Town of Washington Inland Wetlands Commission

APPLICATION TO MODIFY AN APPROVED PERMIT

**INLAND WETLANDS COMMISSION
SITE INSPECTION REPORT**

APPLICATION: MODIFICATION OF APPROVED PERMIT IW-20-07

SITE PLAN		DATE:	02-04-20
BARATTA		SCALE:	1" = 20'
236 NETTLETON HOLLOW ROAD TOWN OF WASHINGTON, CT 06793		FILE:	10-11
		DSGN / CHK:	MG/TA
293 ROUTE 100 SUITE 203 SOMERS, NEW YORK 10589 TEL. 914 277 5805		DRN. BY:	DK
DWG NO. SP-1		SHT NO.:	1 OF 4

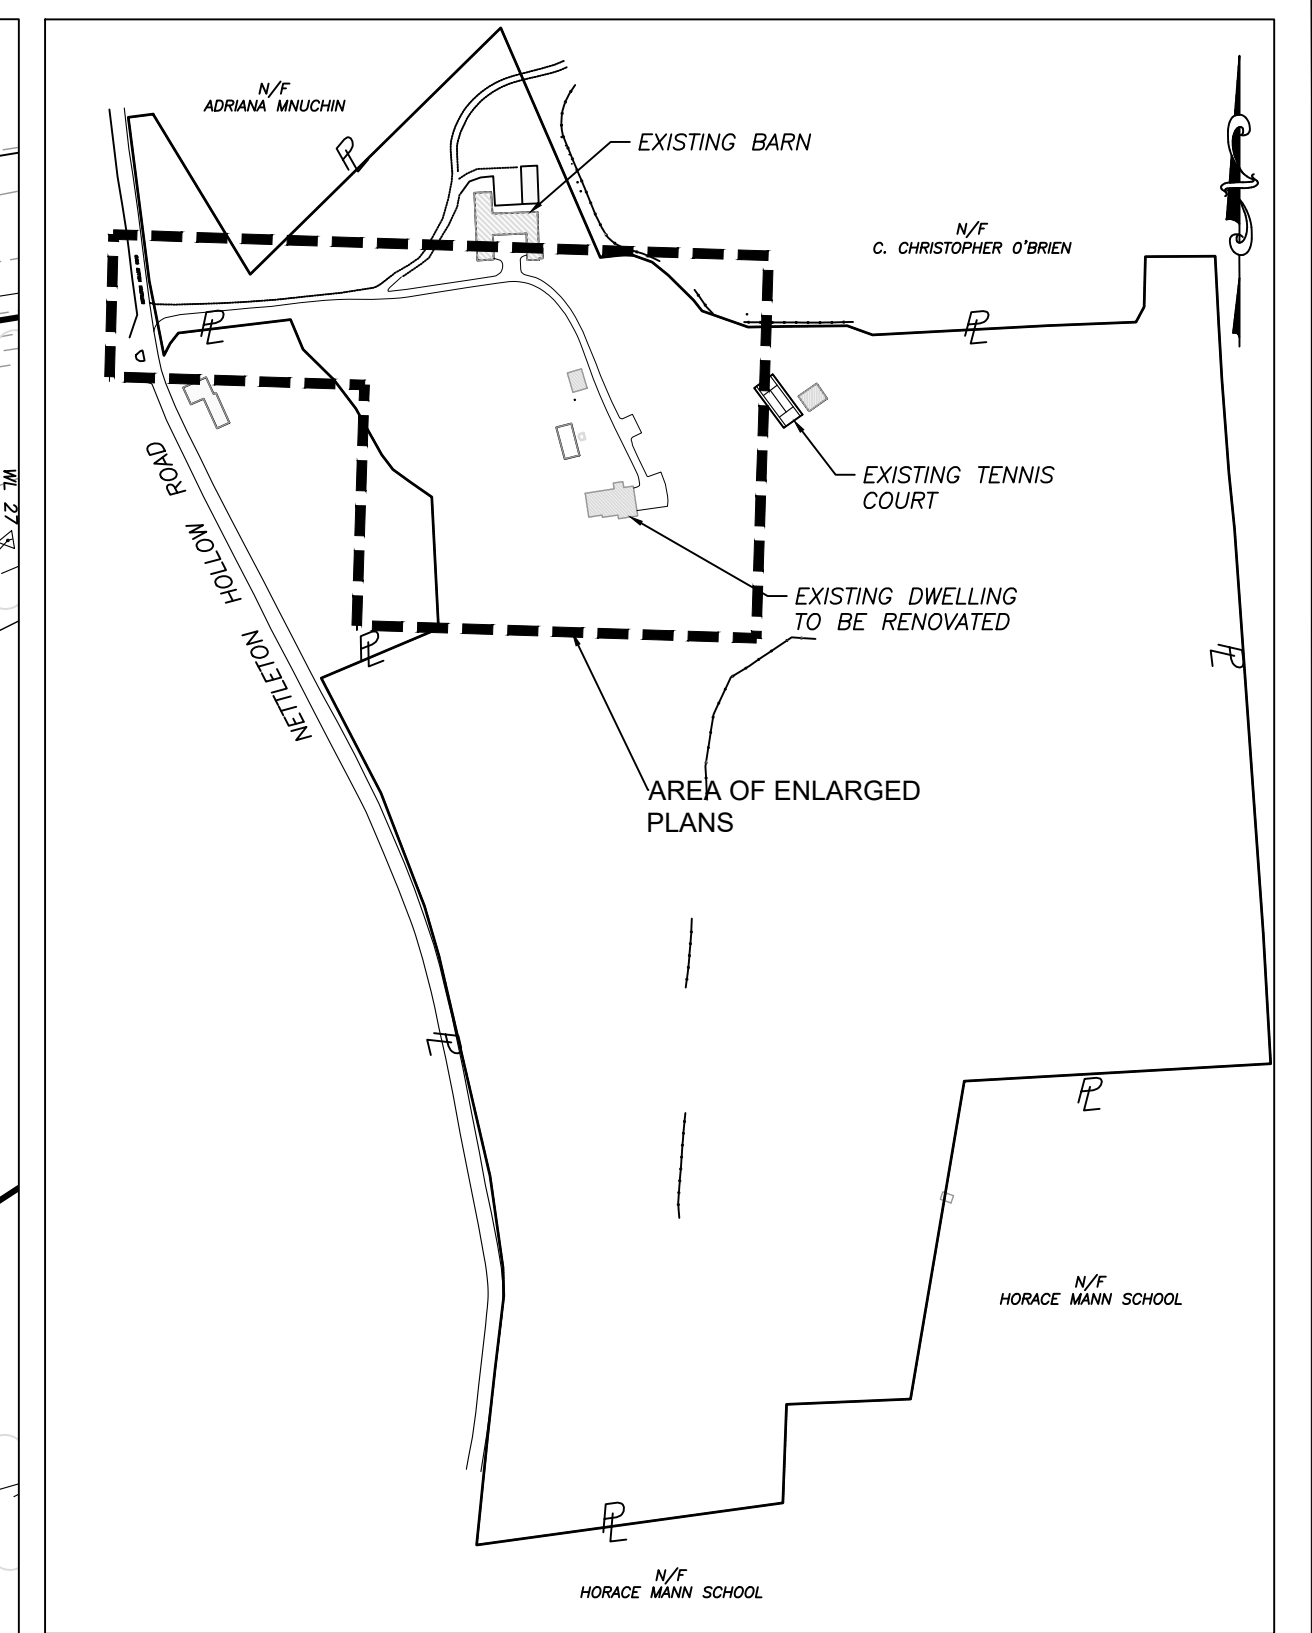
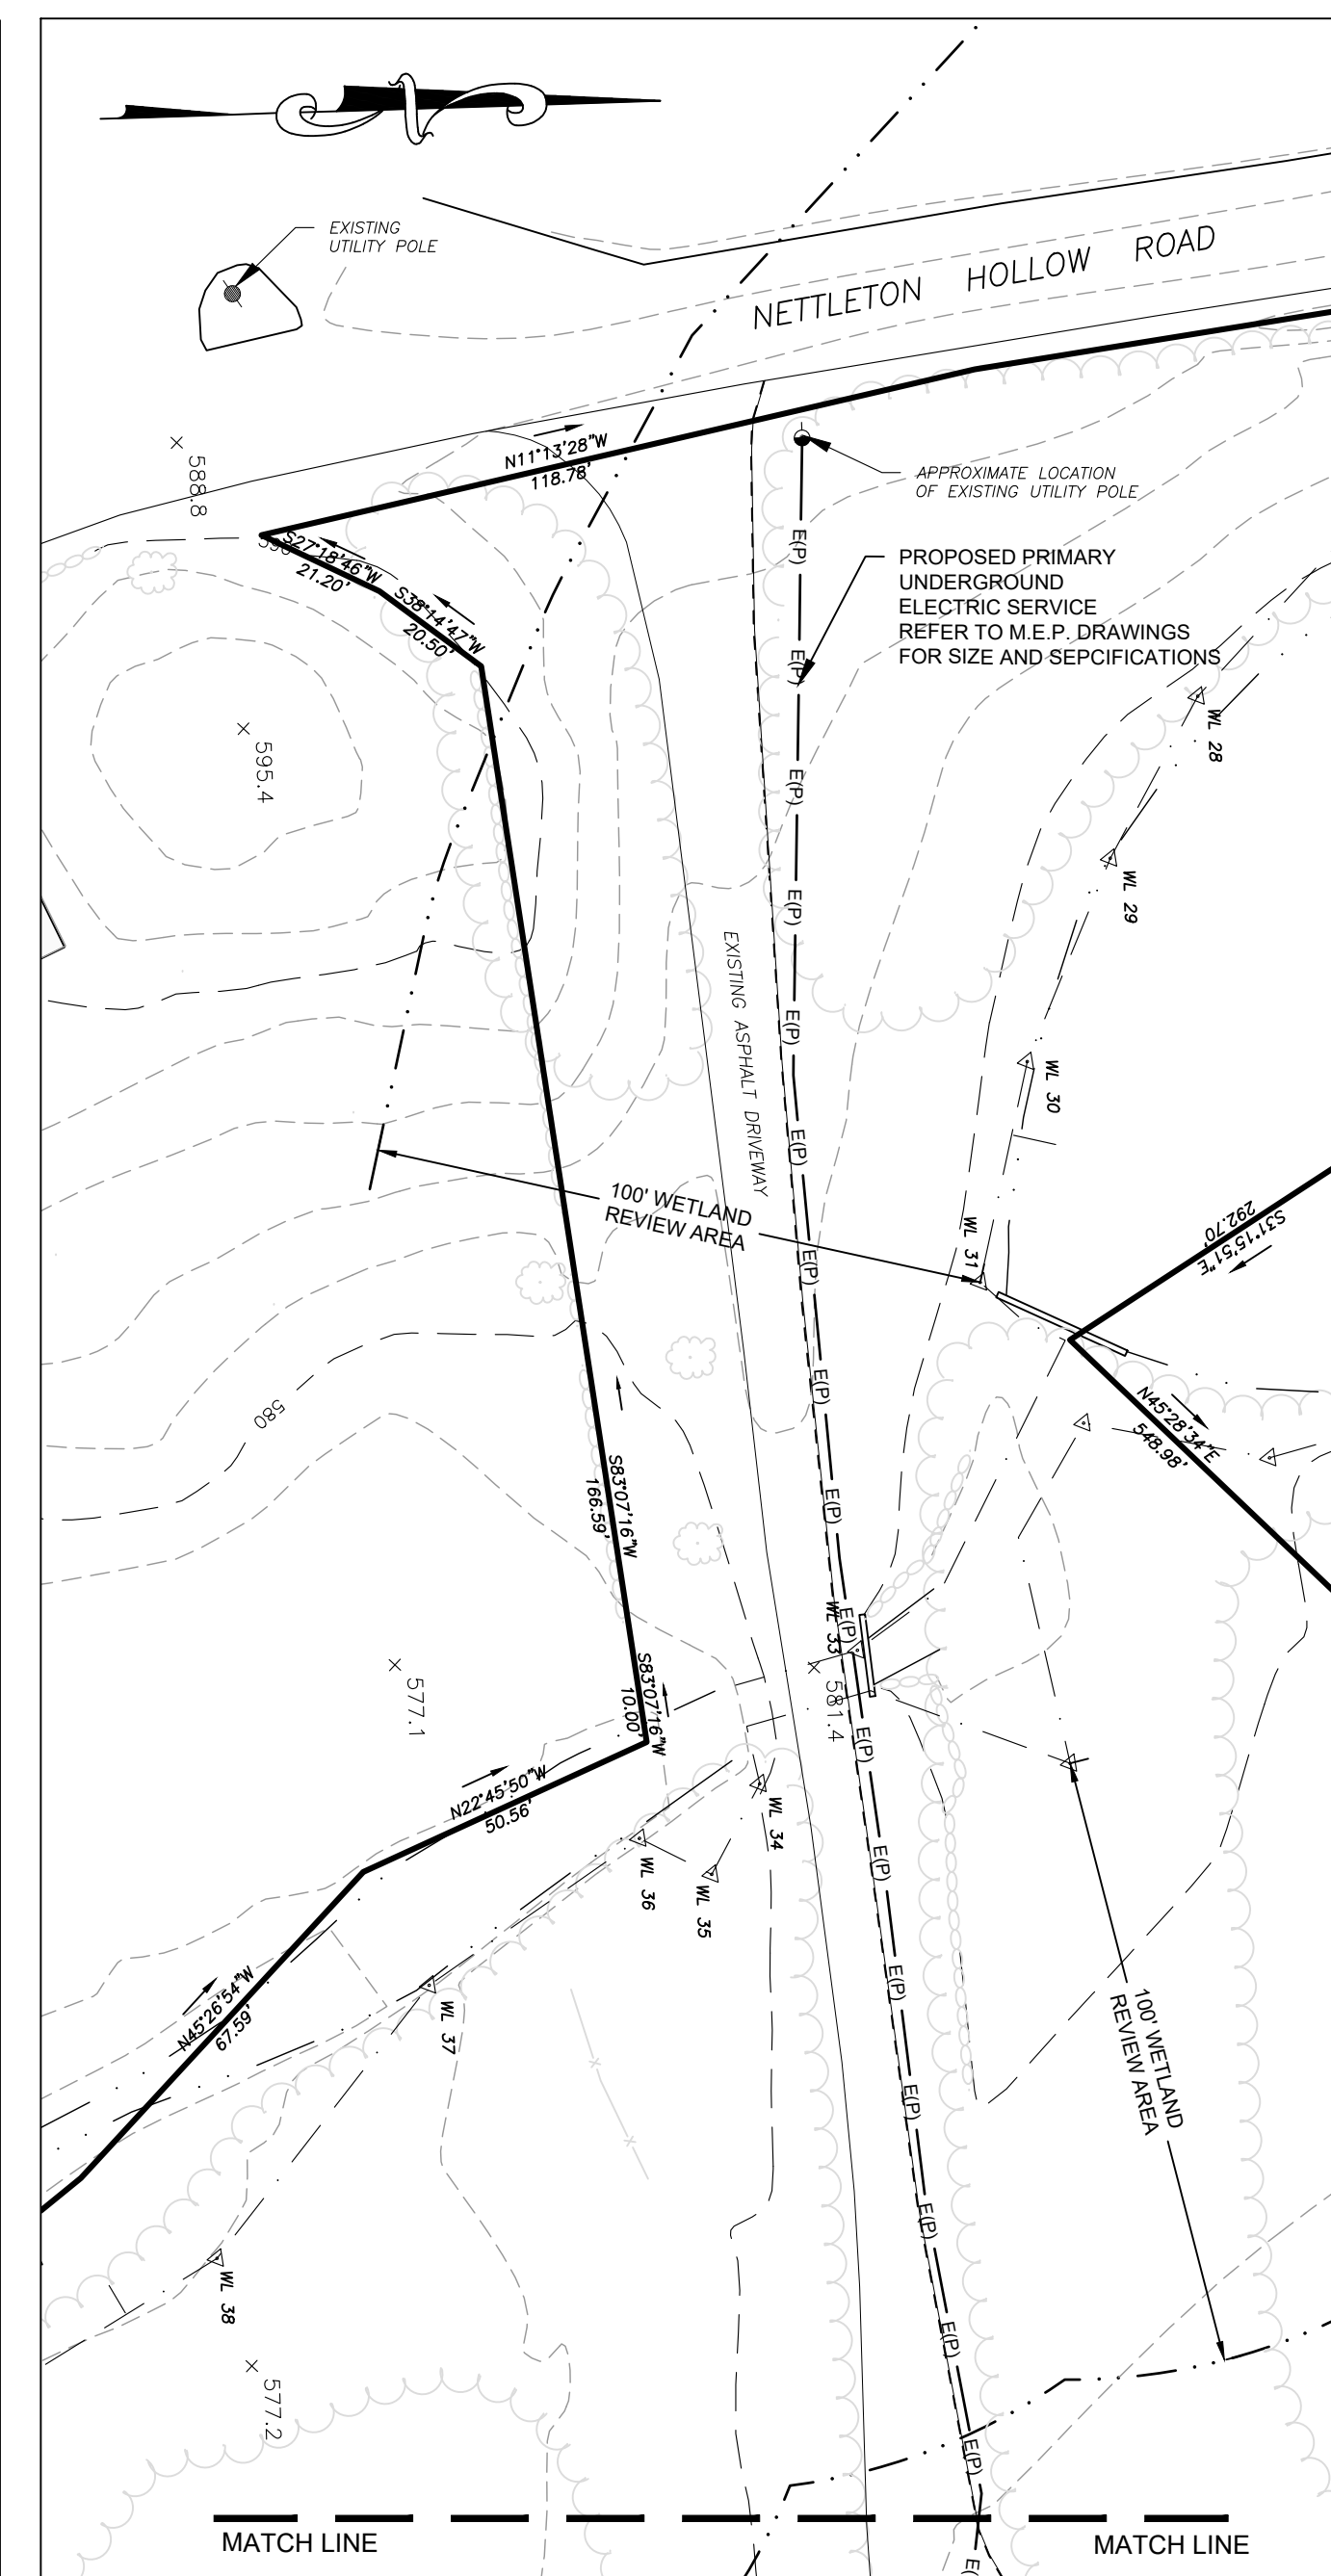
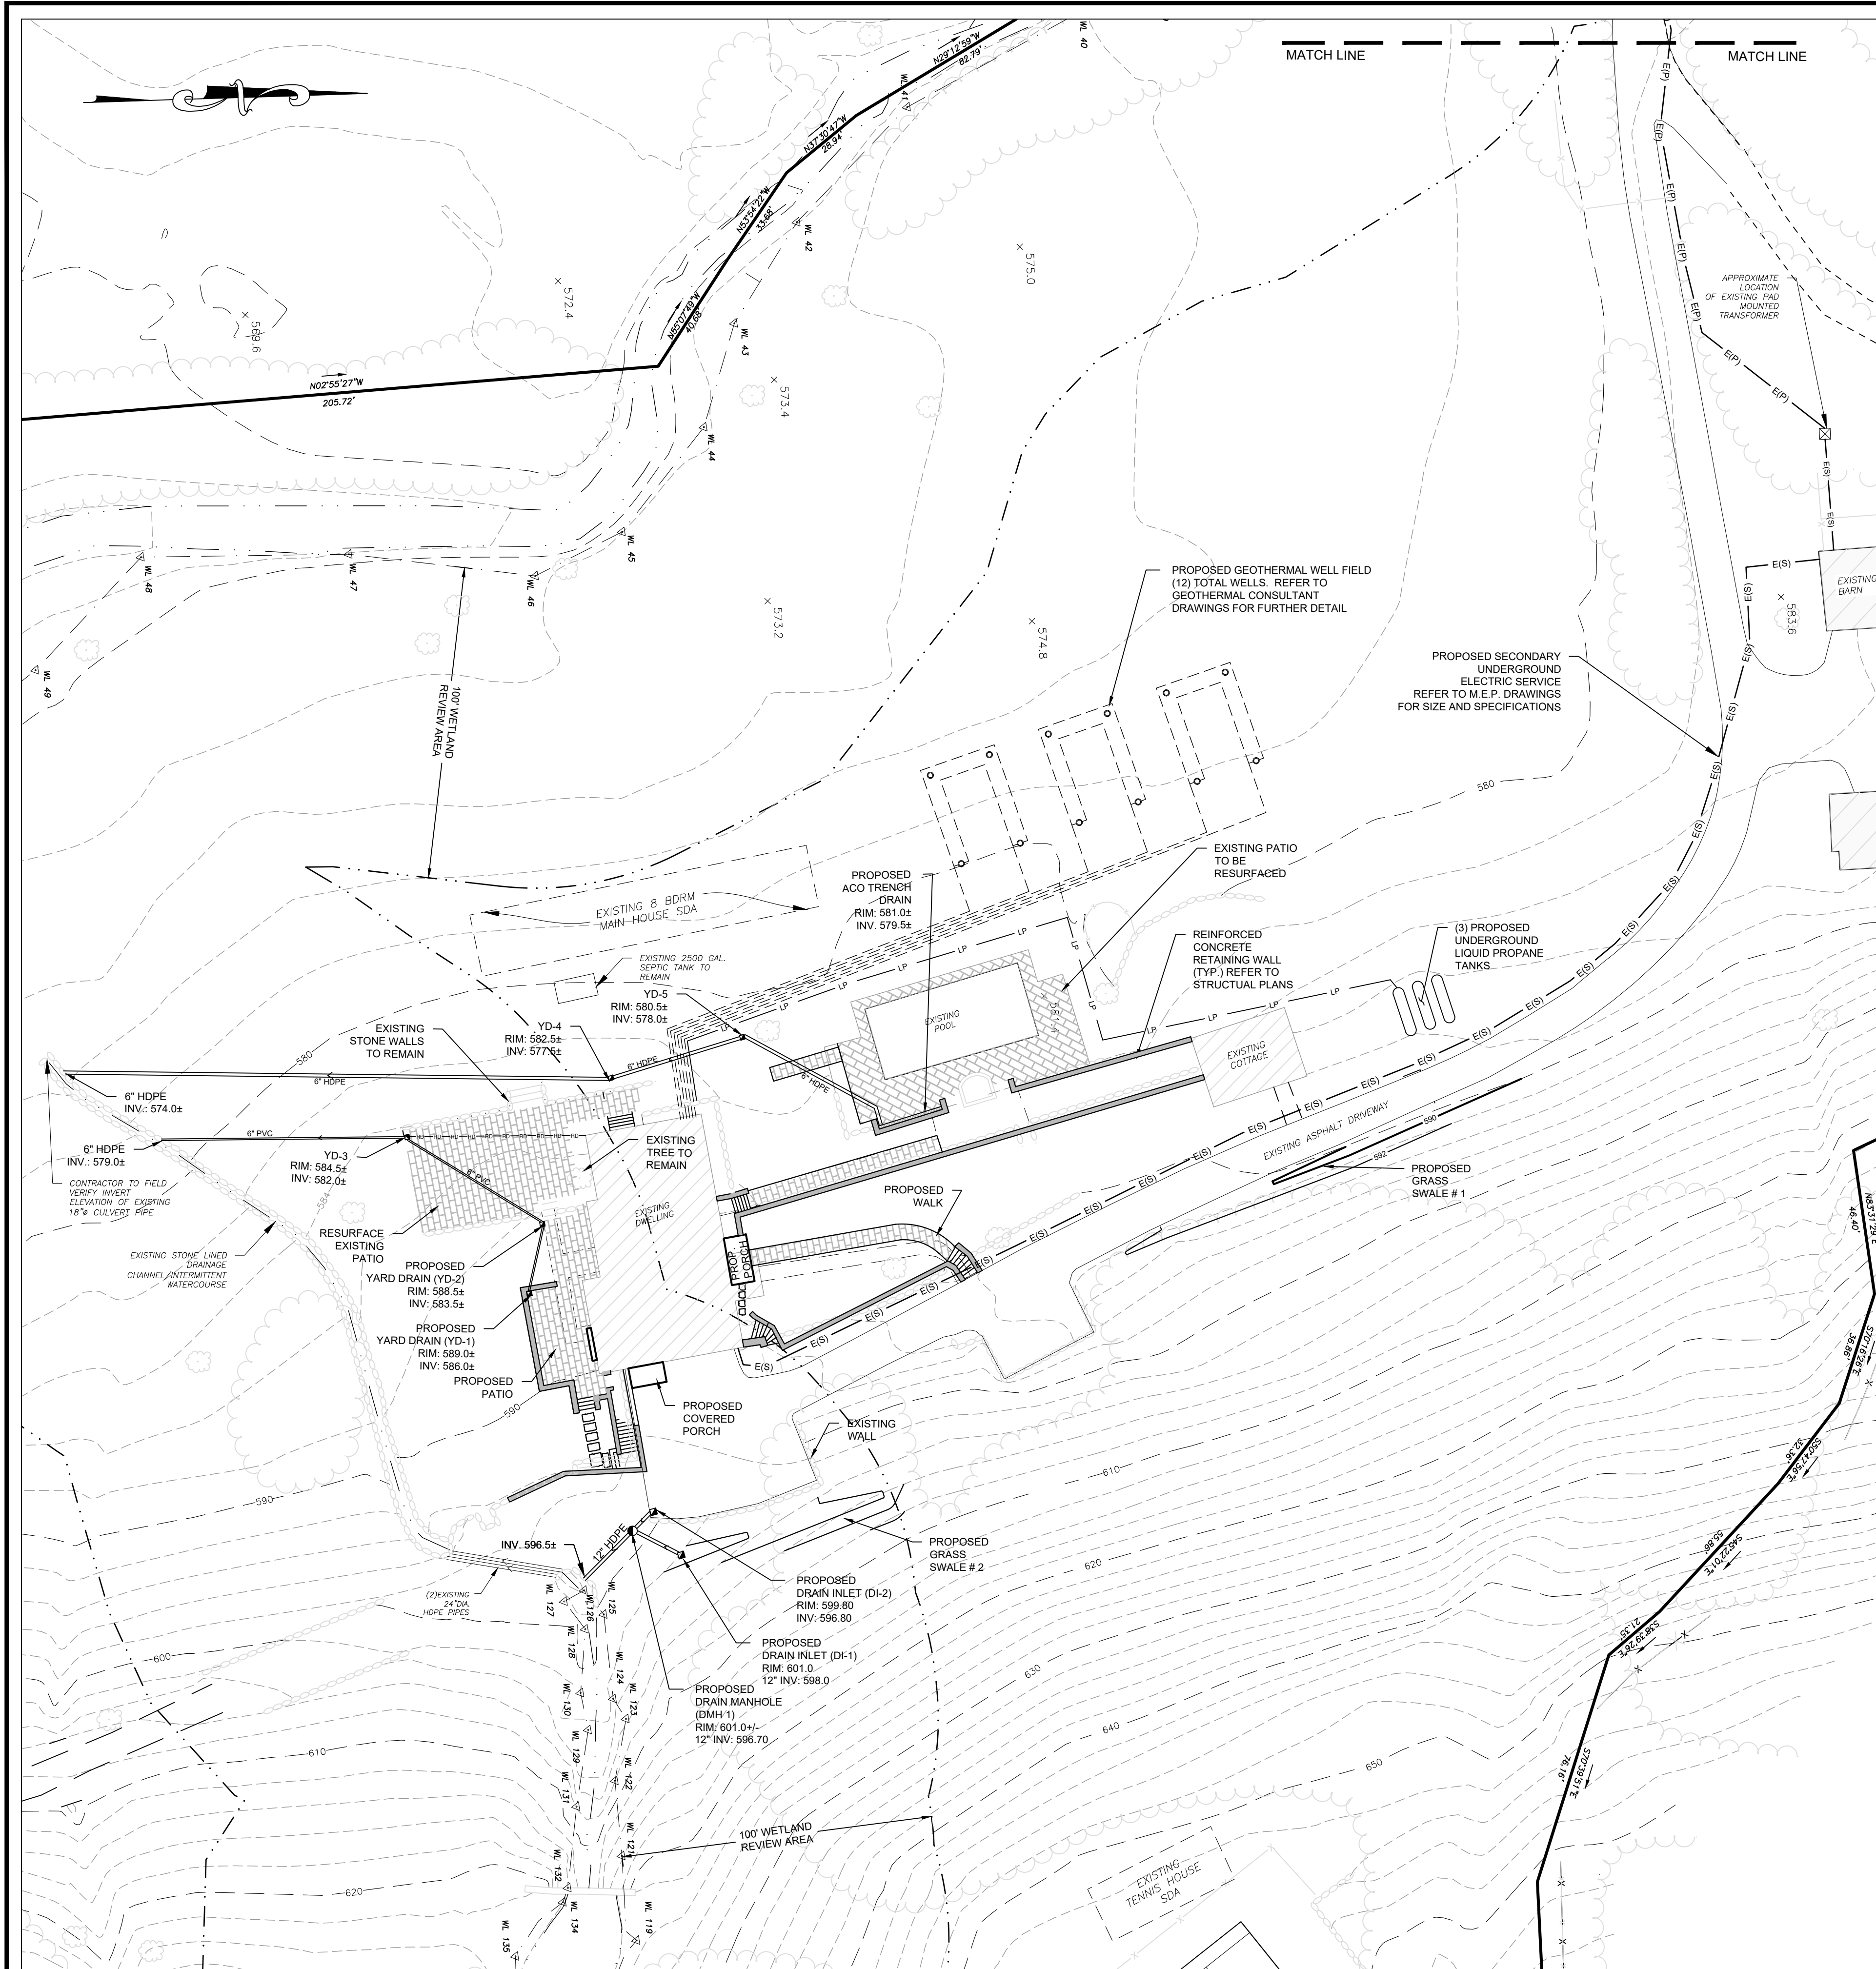
Site Inspection participants gathered in the parking lot adjacent to the house's main entrance. Commissioners requested Mr. Gironda to clarify the discrepancy between his note covering the permit modification request stating that the applicant had now decided not to demolish and reconstruct the existing dwelling, whereas the Sequence of Operations in the 3/8/21 revised EC.1 Plan read in paragraph 4: "Begin demolition of house" and in paragraph 5: "Begin construction of new dwelling". Mr. Gironda explained that the error was due to the inclusion of the unmodified Plan provided as part of the original application and that the error would be corrected.

Commissioners requested that an updated EC.1 Plan be provided which should include a Sequence of Operations more reflective of the work proposed in the permit modification request; a mention of the machinery to be used; and the shown location of the large tree growing close to the house near its southeastern corner, which is not to be cut.

18" X 18" YARD DRAIN DETAIL
N.T.S.

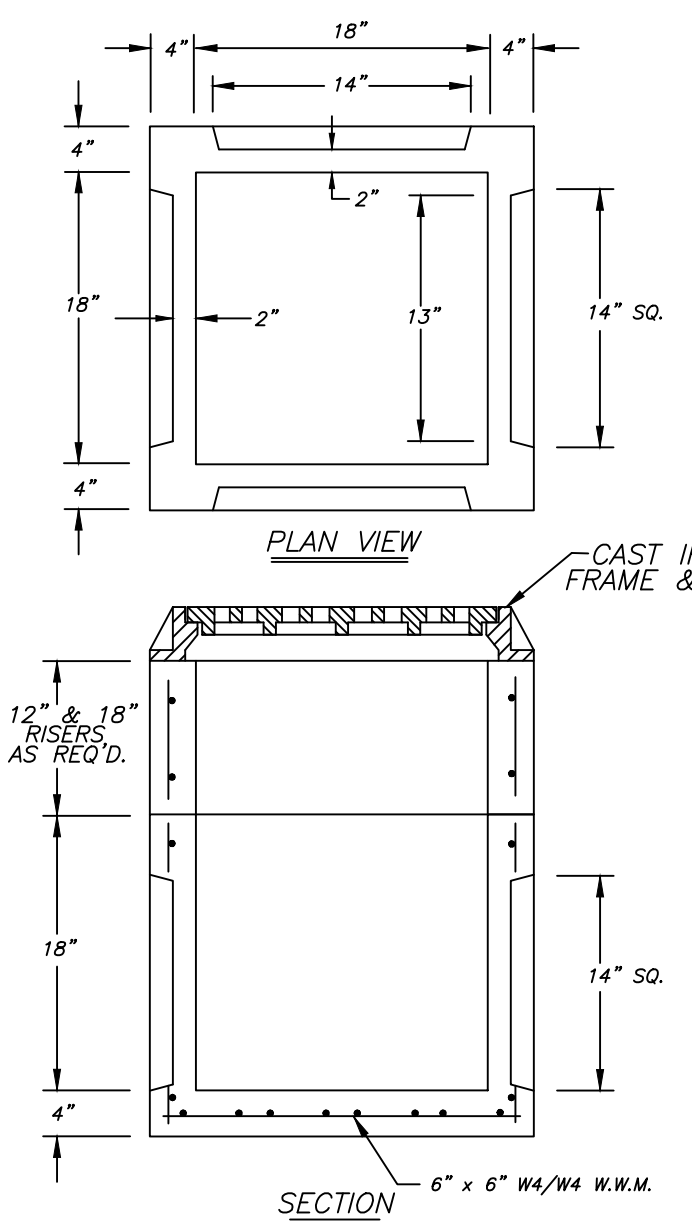
Commissioners then viewed the proposed new patio area on the eastern side of the house that is to be bordered by walls, the specifications of which were not provided. Mr. Gironda informed that the new patio floor would be impervious as the flagstones, laid on a base of sand/stone dust, would be tightly joined. Rainwater, however, would flow to

the edge of the retaining walls where it would be captured at three different locations by Yard Drains before linking on the southwestern corner of the existing large patio with a six-inch pipe that egresses downslope into an intermittent stream. Commissioners requested additional information as to the construction, materials, height and width of the proposed retaining walls.
